issue	description	date	verified
01	Issue for Review	20/7/21	01
02	Issue for Pre-DA	16/9/21	02
03	Issue for Pre-DA	27/9/21	03
04	Issue for DRAFT DA	8/10/21	04
A	Issue for Development Application	21/10/21	A
E	Issue for RFI Response	30/5/22	E

Dairy Farmers Corner

924 Hunter Street 2/DP445736
Newcastle West NSW 2302

Development Application

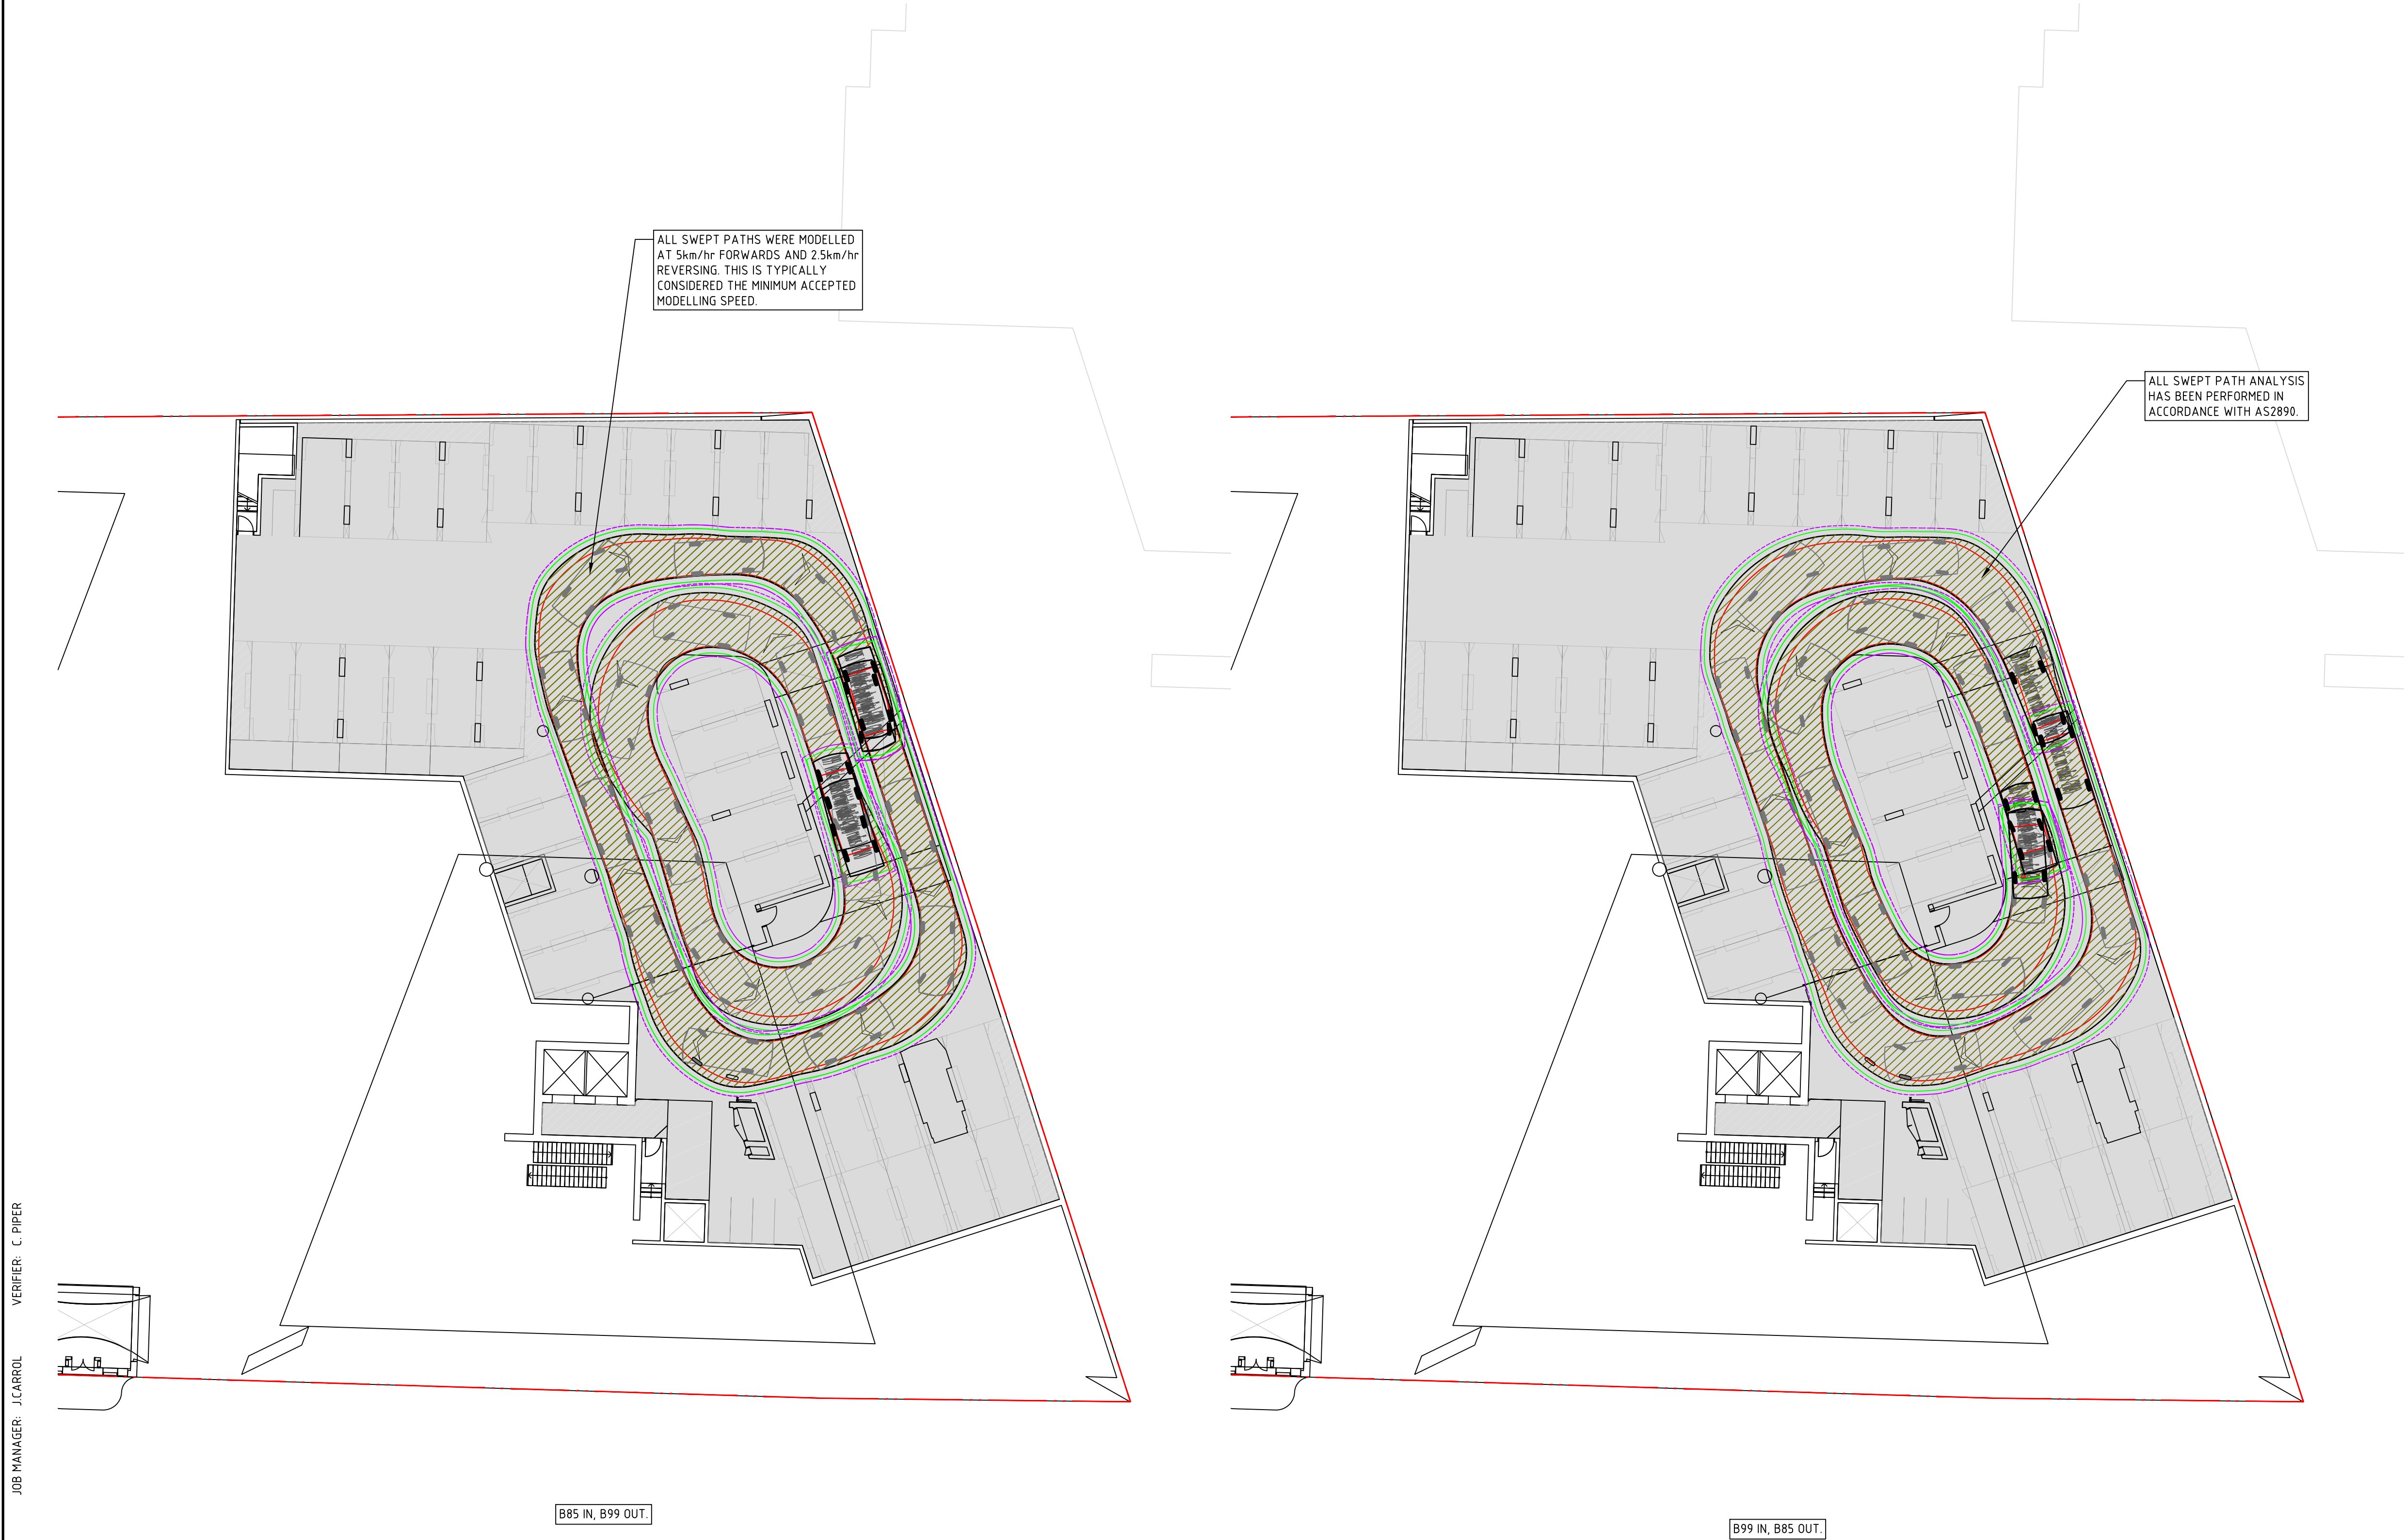
- c) *As previously identified, Clause 2.5.2(c) of AS2890.1 requires that areas within a carpark where it may be necessary for two vehicles to pass on a ramp structure, the design is to prove that a B85 vehicle can safely pass a B99 vehicle with relevant clearances. The vehicle turning paths provided on previous Engineering Plan (DA-C06.01 Rev 1) showed an assessment for two B85 vehicles to pass when turning. The amended Civil Engineering Plan (Northrop DA-C06.01 Rev 2) now only shows the B85 and B99 vehicles passing on the straight ramp sections. Additional swept path templates are to be provided proving that these vehicles can pass, with relevant clearances, when turning at the top and bottom of the ramps.*

Clause 2.5.2(c) of AS2890.1 requires that where potential exists for two vehicles to pass on a ramp structure, the design is to prove that a B85 vehicle can safely pass a B99 vehicle with relevant clearances. The vehicle turning paths provided on Engineering Plan DA-C06.01 shows that an assessment has been made only for two B85 vehicles to pass. Additional information confirming compliance with AS2890.1 is required to be submitted.

As previously identified, Clause 2.5.2(c) of AS2890.1 requires that areas within a carpark where it may be necessary for two vehicles to pass on a ramp structure, the design is to prove that a B85 vehicle can safely pass a B99 vehicle with relevant clearances. The vehicle turning paths provided on previous Engineering Plan (DA-C06.01 Rev 1) showed an assessment for two B85 vehicles to pass when turning. The amended Civil Engineering Plan (Northrop DA-C06.01 Rev 2) now only shows the B85 and B99 vehicles passing on the straight ramp sections. Additional swept path templates are to

Swept path plans have been included that show a B85 and B99 passing each other at the top and bottom of the ramp for each level, enclosed. As is shown C06.02, sufficient clearances are generally provided in accordance with B3.2 of AS2890.1. Drawing C06.03 and C06.04 shows generally sufficient clearance is provided except for a conflict on the northern corner of each level. Drawing C06.05 shows generally sufficient clearance is provided except for a conflict on the southern corner. Please refer to traffic engineer responses for further clarification.
